**STAFF SUMMARY
JUNE 3rd, 2020 PLANNING AND ZONING COMMISSION
REGULAR MEETING**

ACTION TO BE CONSIDERED: Consideration of Resolution No. PZ 06-20, Series of 2020:
**A RESOLUTION APPROVING A LEVEL III DEVELOPMENT APPLICATION
FOR AN ACCESSORY STRUCTURE ON A COMMERCIAL ZONED
PROPERTY AT 166 LAKE DILLON DRIVE.**

CenturyLink
 DILLON PARKING STRUCTURE
 166 LAKE DILLON DRIVE
 DILLON, COLORADO

Proposed Accessory Structure

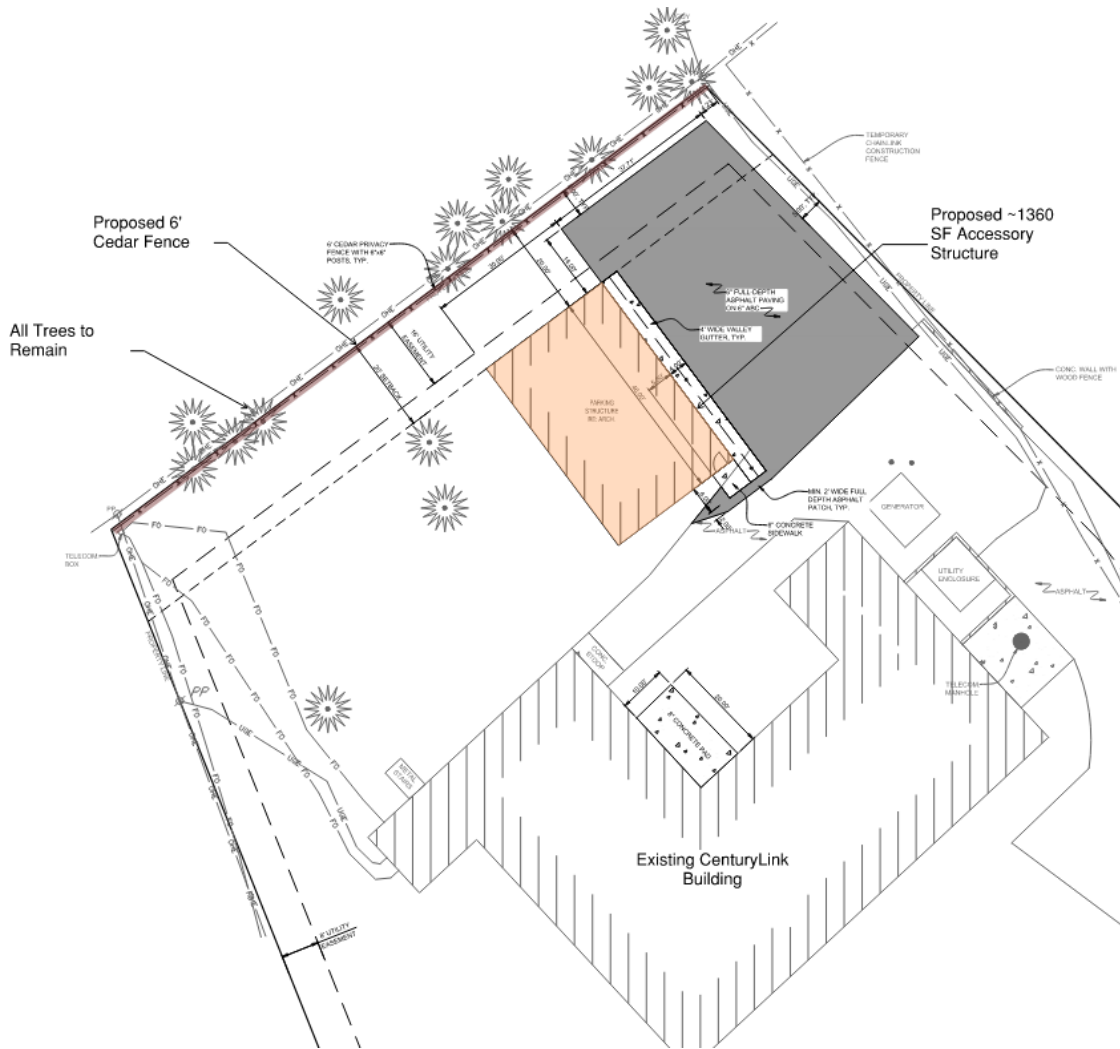
The accessory structure meets the 20' rear yard setback and maximum building height of the commercial zone district and is architecturally compatible with the existing improvements on the site. The vertical siding has a similar texture as the primary structure and has an Earthtone color similar to the primary structure.

Natural Earthtone Colors: Beige building material and Brown trim and doors.
